City of Detroit
Inter-Departmental Communication

RE: Petition No. 1054
Requested Encroachment Into Wyoming And Desoto At 15100 Wyoming Bound
By Ellsworth, Desoto, Wyoming And Cherry lawn

**REQUEST ENCROACHMENT
 INTO WYOMING AVE.
 AND DE SOTO AVE.
 AT 15100 WYOMING AVE.**

DRWG. NO. X 1054

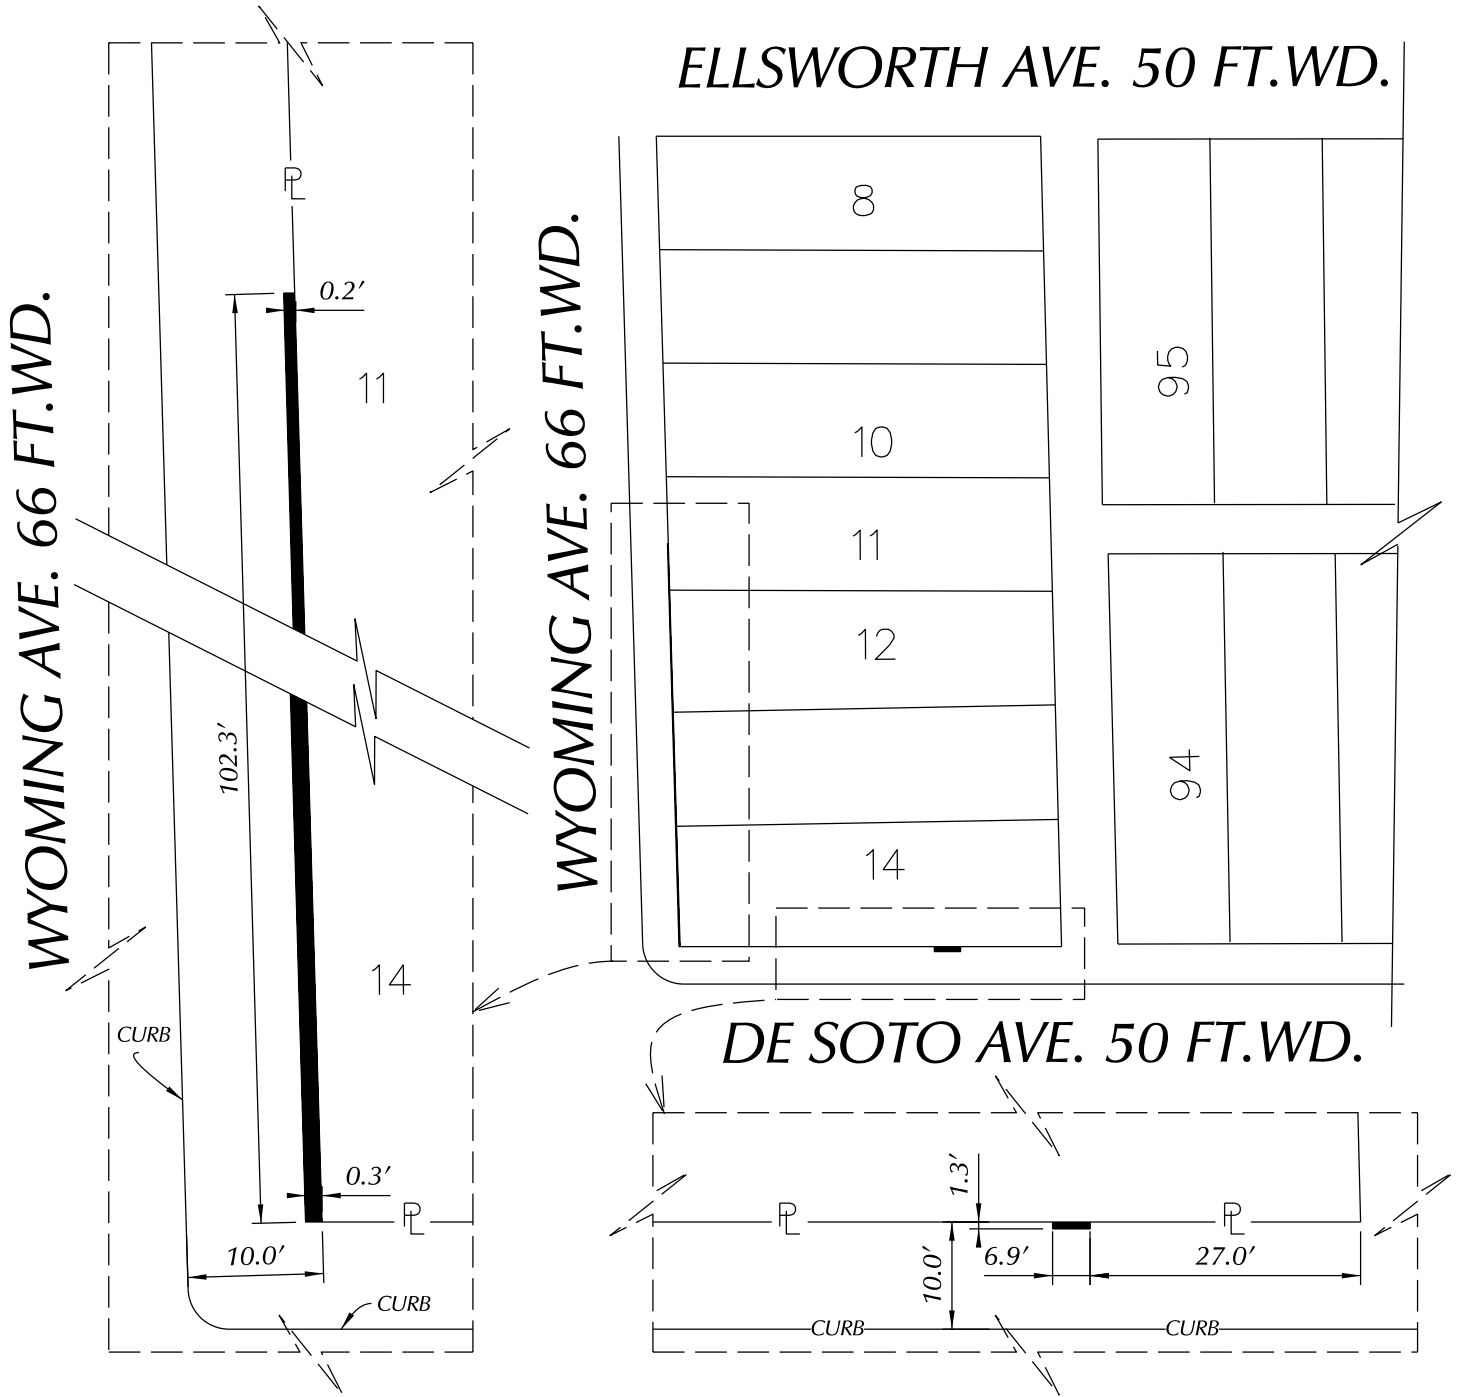
- Our records indicate there are a water main and sewers in the right of way in the requested area of encroachment. DWSD has no objections to the requested encroachments provided that the attached Provisions for Encroachment are strictly followed.

1. By approval of this petition the (DWSD) does not waive any of its rights to its facilities located in the right of way, and at all time, DWSD, its agents or employees, shall have the right to enter upon the right of way to maintain, repair, alter, service, inspect, or install its facilities. All costs incident to the damaging, dismantling, demolishing, removal and replacement of structures or other improvements herein permitted and incurred in gaining access to DWSD's facilities for maintenance, repairing, alteration, servicing or inspection caused by the encroachment shall be borne by the petitioner. All costs associated with gaining access to DWSD's facilities, which could normally be expected had the petitioner not encroached into the right of way shall be borne by DWSD.

2. DWSD requires a vertical clearance of 18 feet above grade for maintenance excess and repair.
3. All construction performed under this petition shall not be commenced until after five (5) days written notice to DWSD. Seventy-two (72) hours notice shall also be provided in accordance with P.A. 53 1974, as amended, utilizing the MISS DIG one call system.

4. Construction under this petition is subject to inspection and approval by DWSD forces. The cost of such inspection shall, at the discretion of DWSD, be borne by the petitioner.

5. If DWSD facilities located within the right of way shall break or be damaged as the result of any action on the part of the petitioner, then in such event the petitioner agrees to be liable for all costs incident to the repair, replacement or relocation of such broken or damaged DWSD facilities.

6. The petitioner shall hold DWSD harmless for any damage to the encroaching device constructed or installed under this petition, which may be caused by the failure of DWSD's facilities.
